ADDENDUM 01

BID FOR : *Campus Gateways, McNeese State University, Lake Charles, Louisiana 70607*

Addendum No. 01

PROJECT:
Campus Gateways
McNeese State University
Lake Charles, Louisiana
19-627-21-01, F.19002583
01-107-05B-13, F.01004545 (Supplement)

A-521R1
GATEWAYS SIGNAGE

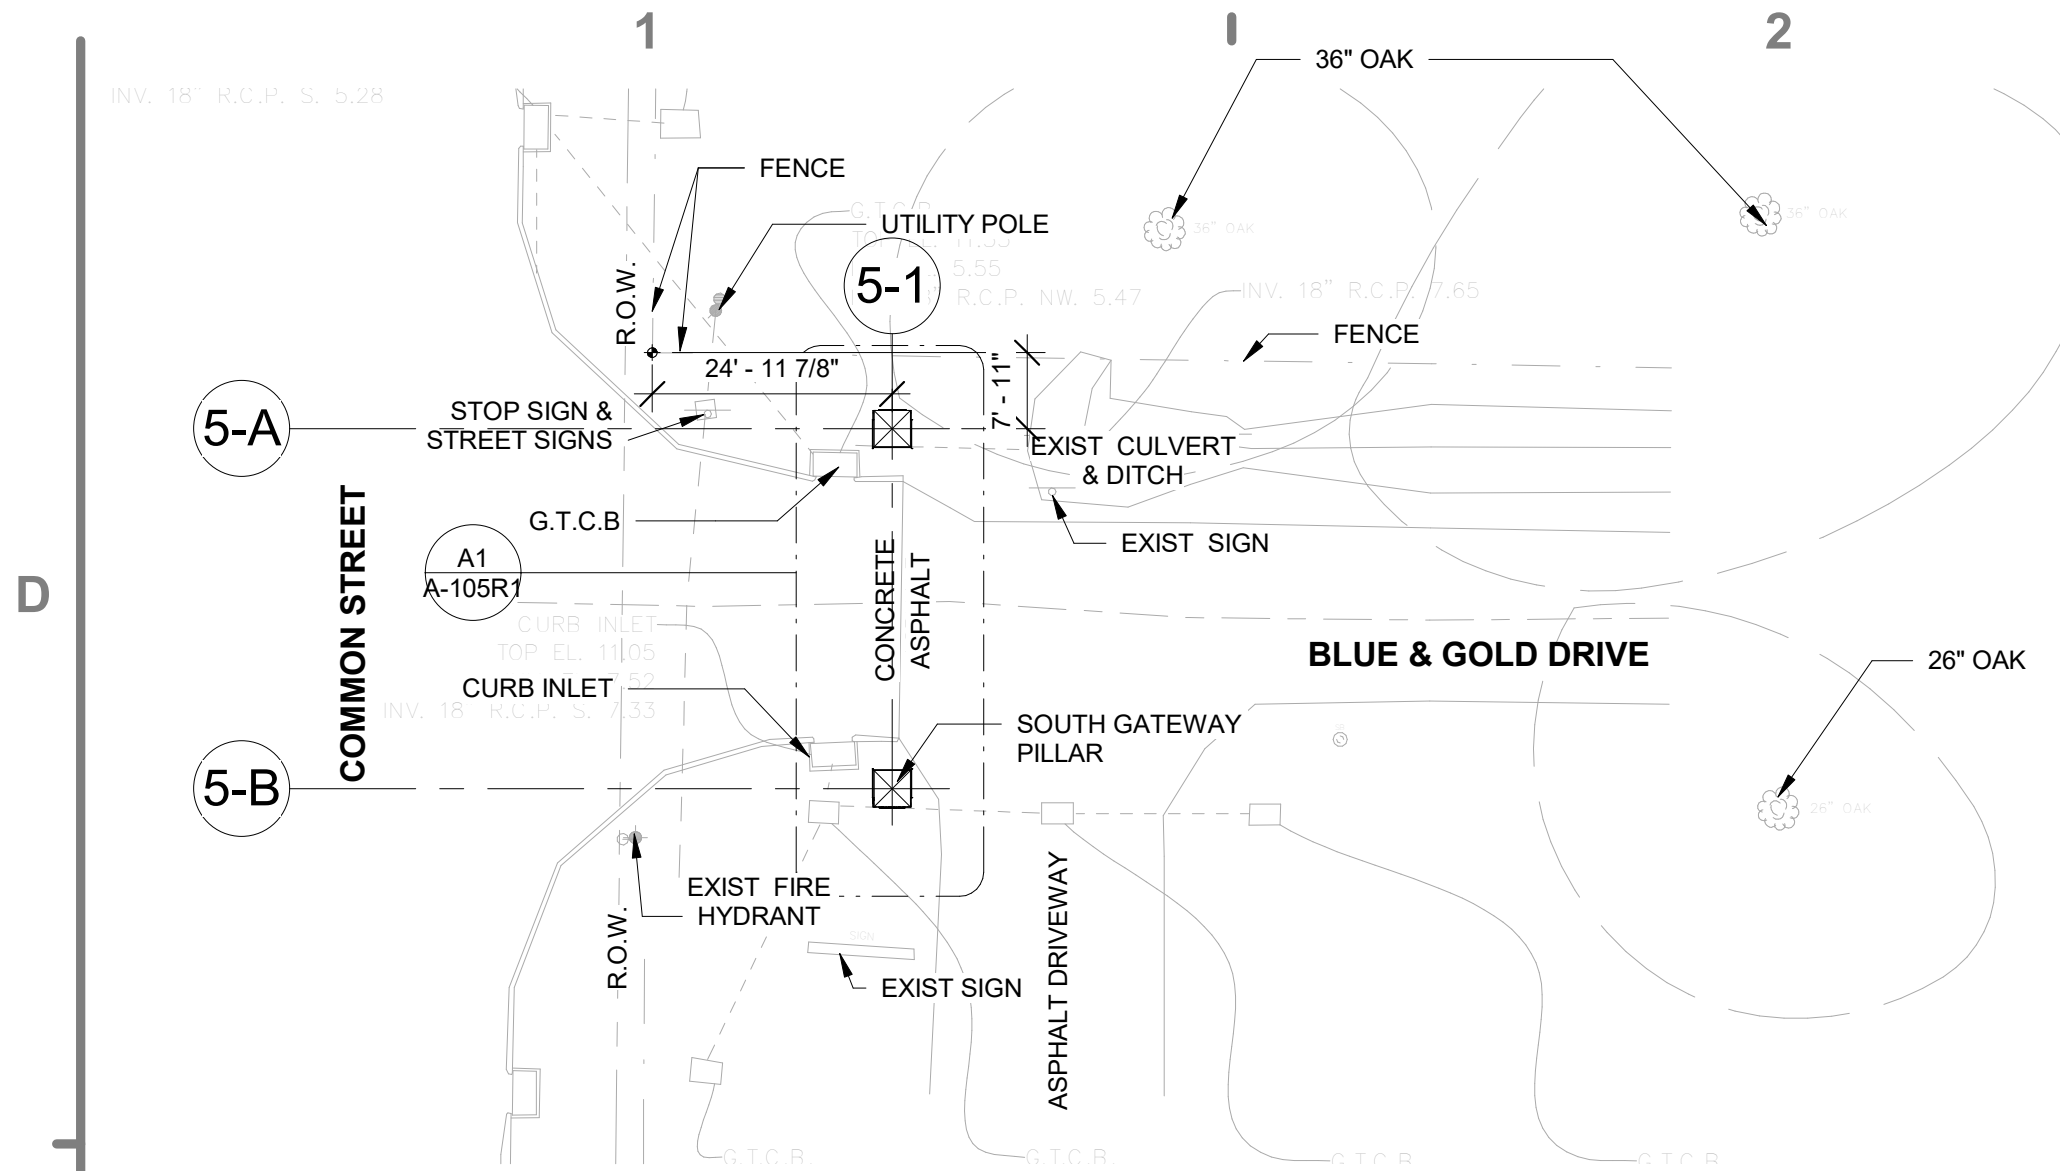
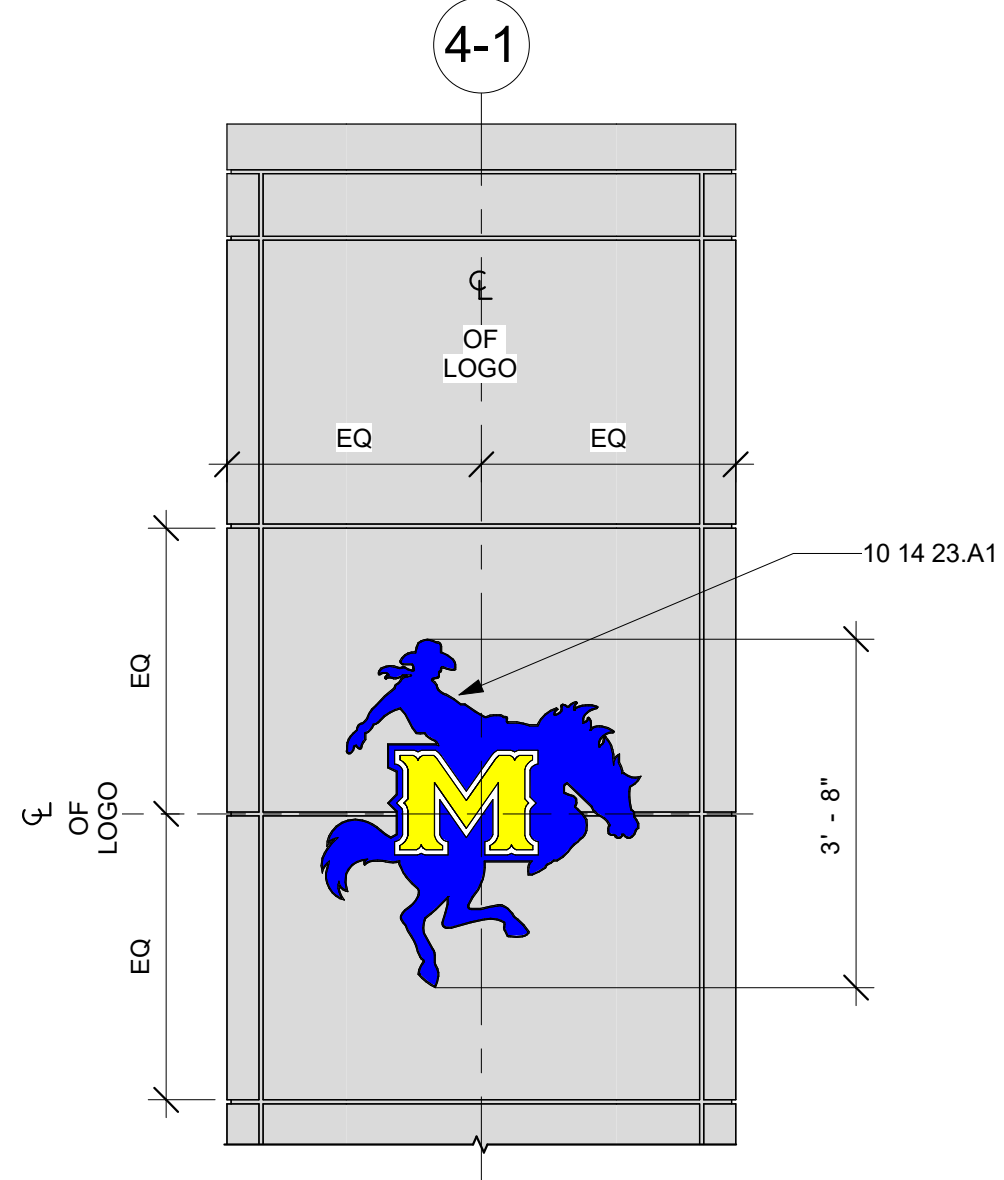
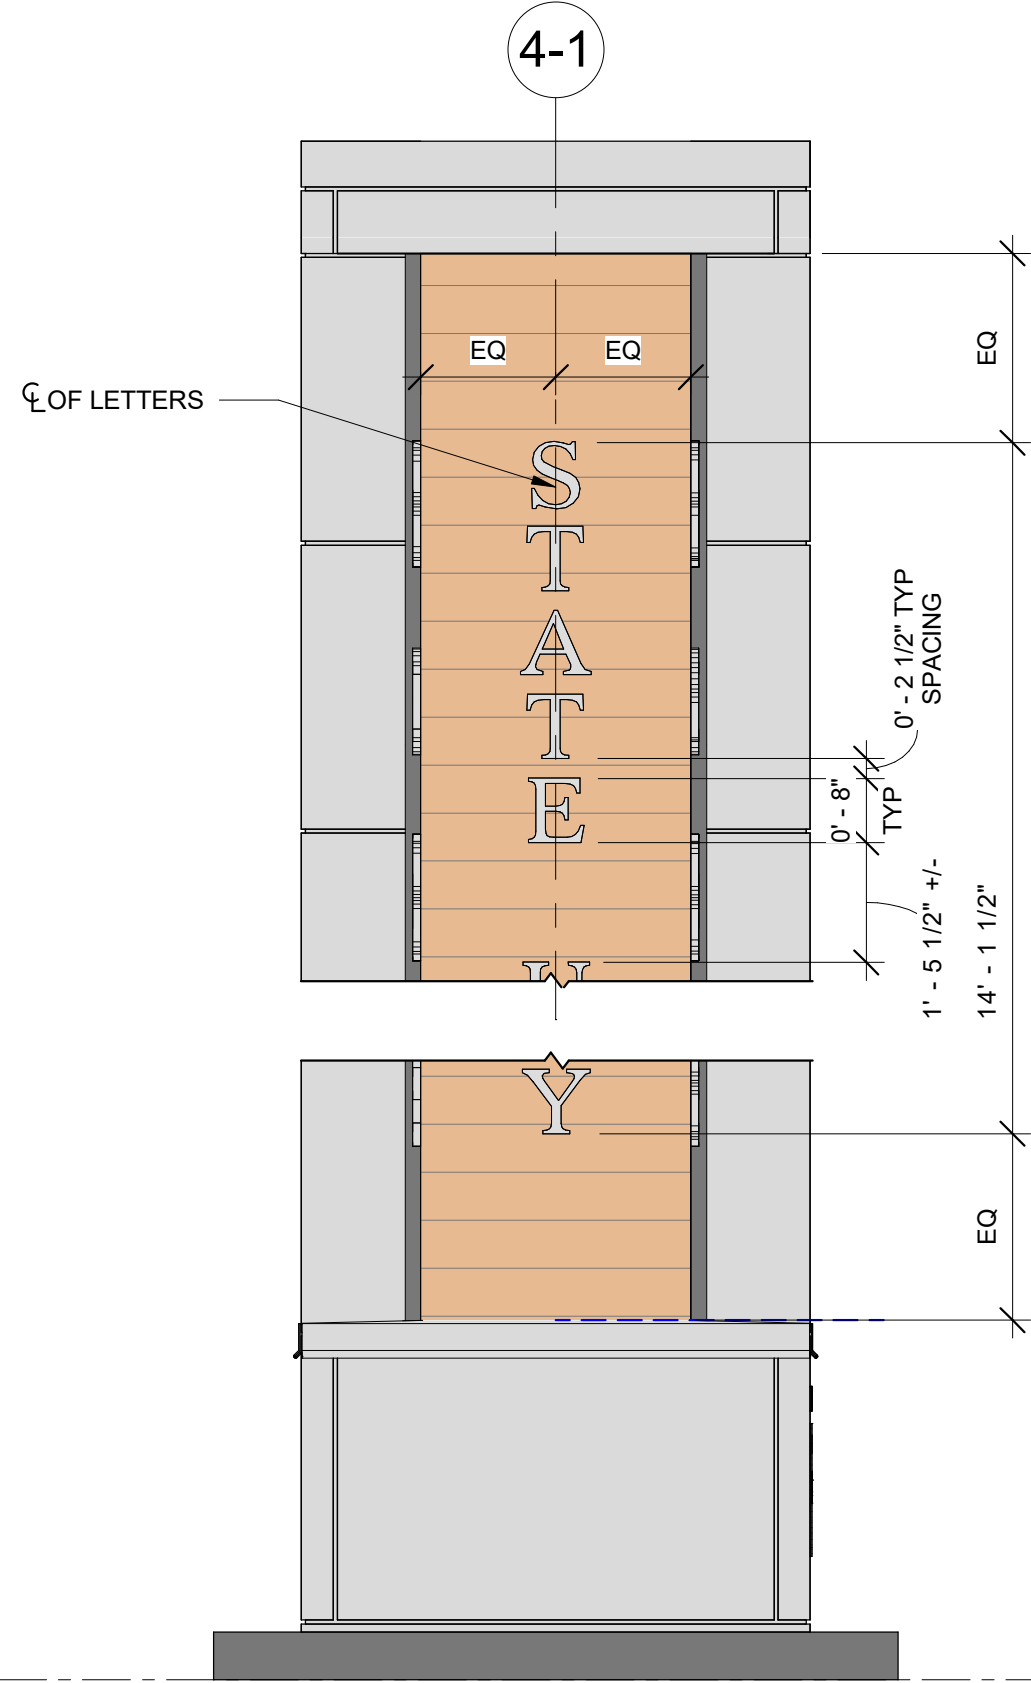
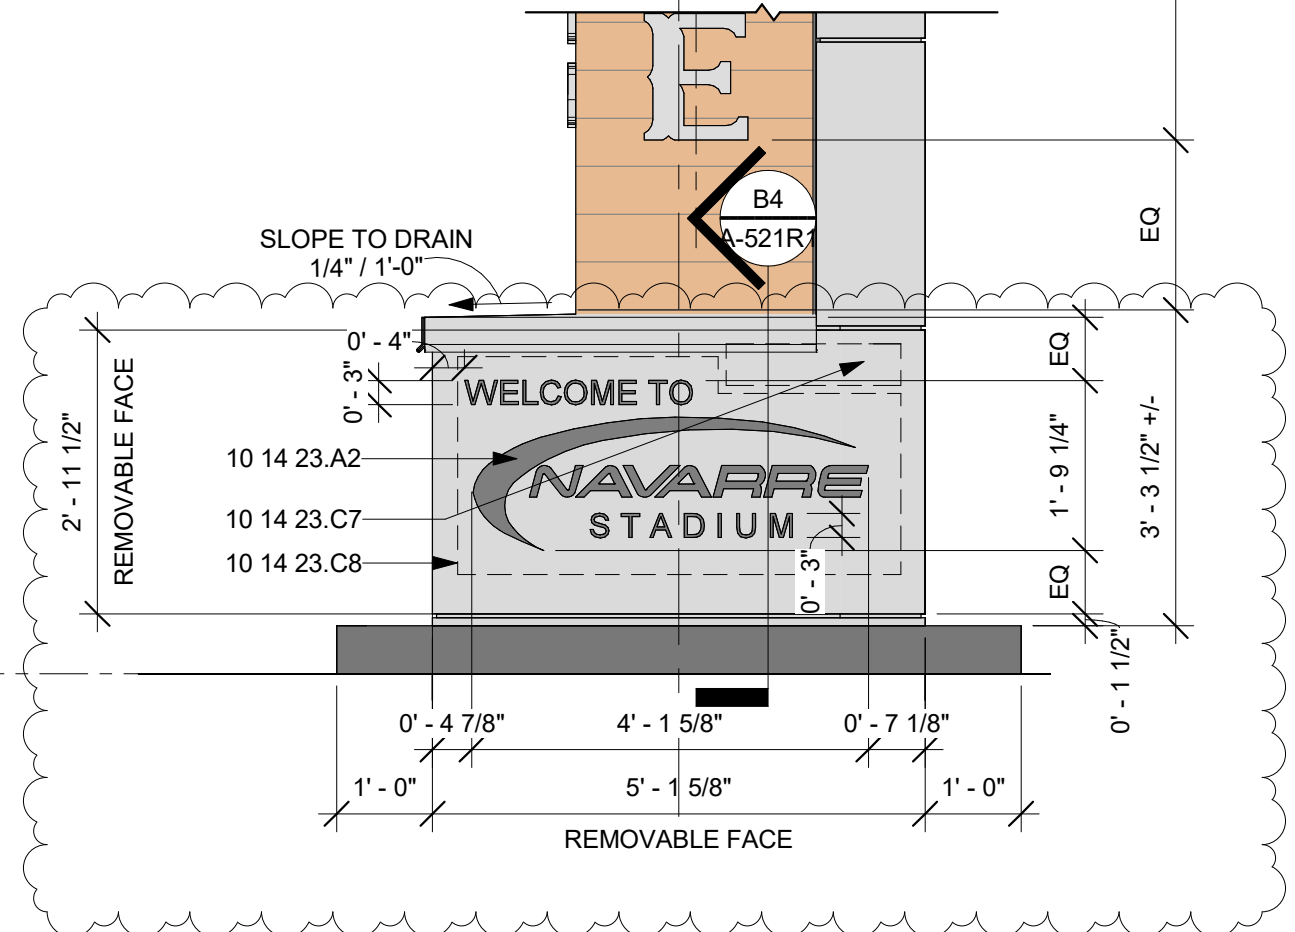
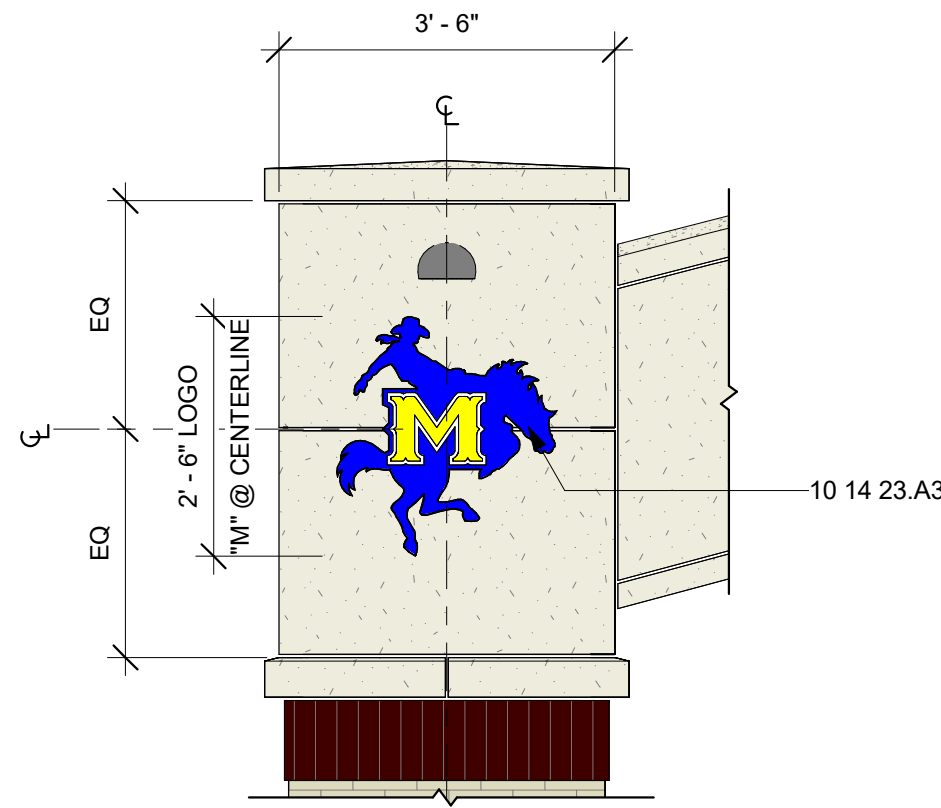
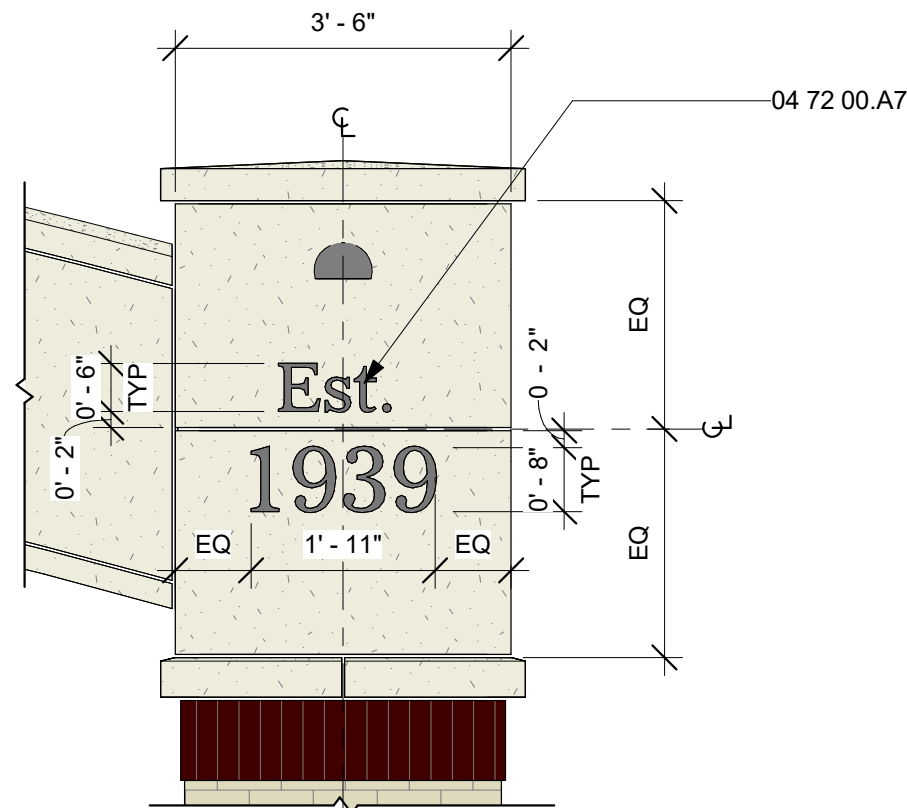
- a. Sheet A-104R1 Gateway 04- Plans and Elevations.
- b. Sheet A-105R1 Gateway 05- Plans and Elevations.
- c. Sheet A-521R1 Gateway Signage.
